**LEAKS—WATER—AT FRONT TOP SIDE  
CONVERTIBLE WEATHERSTRIPS**

**Article No.  
96-10-1**

**MERCURY:** 1991-1993 CAPRI

Figure 1 - Article 96-10-1

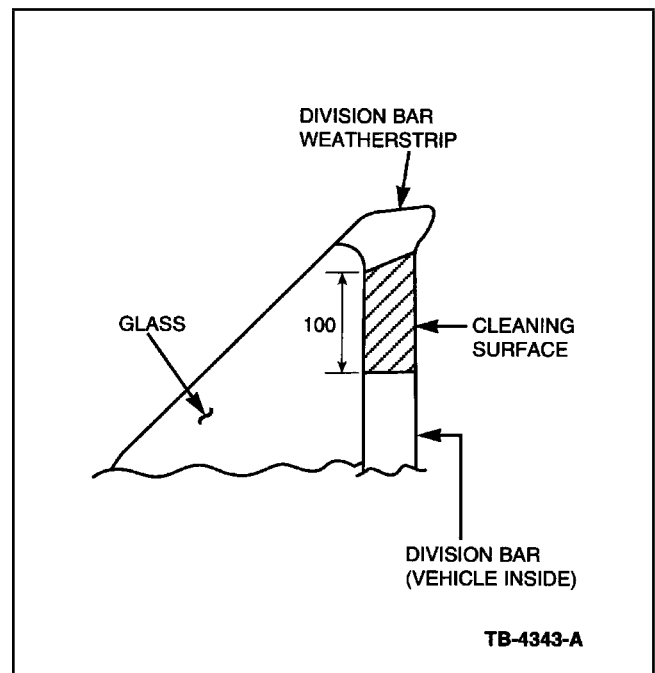
1. Be sure the top is securely locked on the header. Clean the surface of the division bar with rubbing alcohol or wax and grease remover. Refer to Figure 1.

Figure 2 - Article 96-10-1

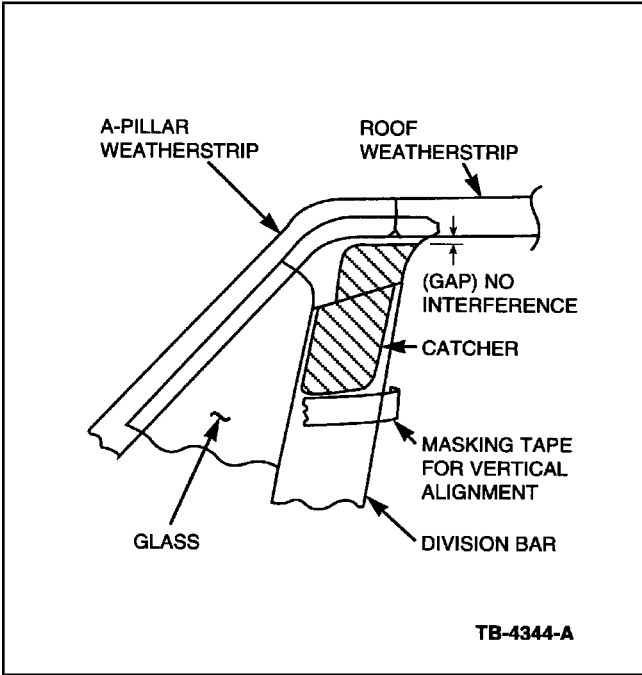
2. From inside the vehicle, close the door and confirm the position of the division bar weatherstrip and roof weatherstrip. Position the catcher so that it will not interfere with the roof weatherstrip when you open/close the door. While holding the catcher in position, place a small piece of tape on the division bar along the bottom edge of the catcher to mark its position. Refer to Figure 2.

Figure 3 - Article 96-10-1

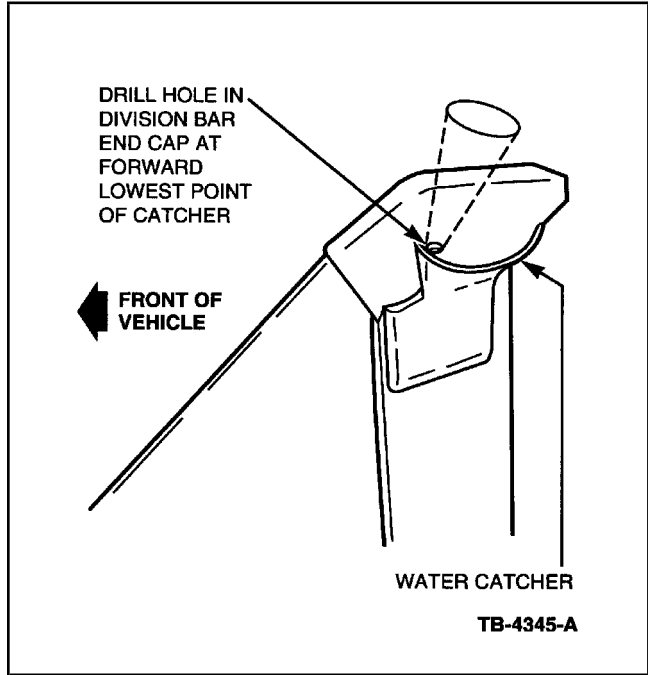
3. Open the door and, using the tape mark, align the catcher with the division bar. Make sure the water catcher is aligned both vertically and parallel to the division bar. Mark the location of the hole at the forward edge of the water catcher using an awl or similar tool. Drill a 3/16" hole into the division bar end cap. Refer to Figure 3.

Figure 4 - Article 96-10-1

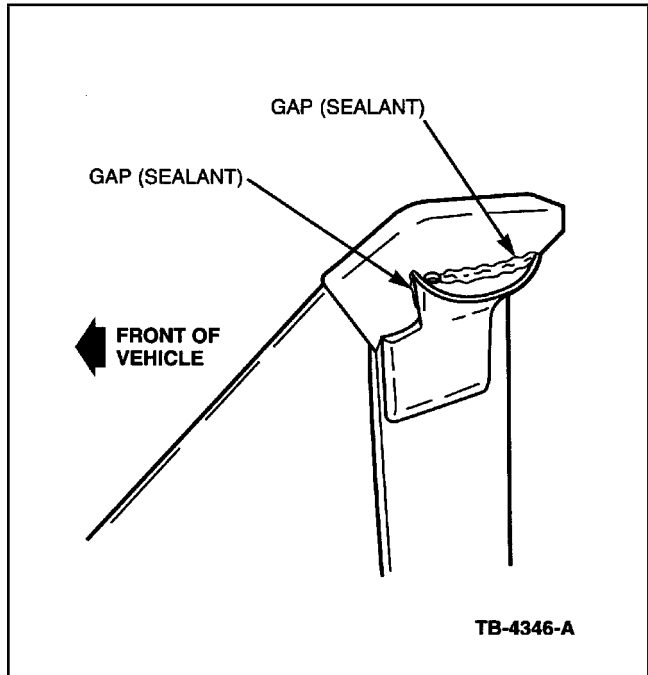
5. With the catcher properly positioned, firmly press the catcher onto the division bar. Use a fine tipped tube of RTV Black Sealant and fill any small gaps between the catcher and the division bar. Refer to Figure 4.
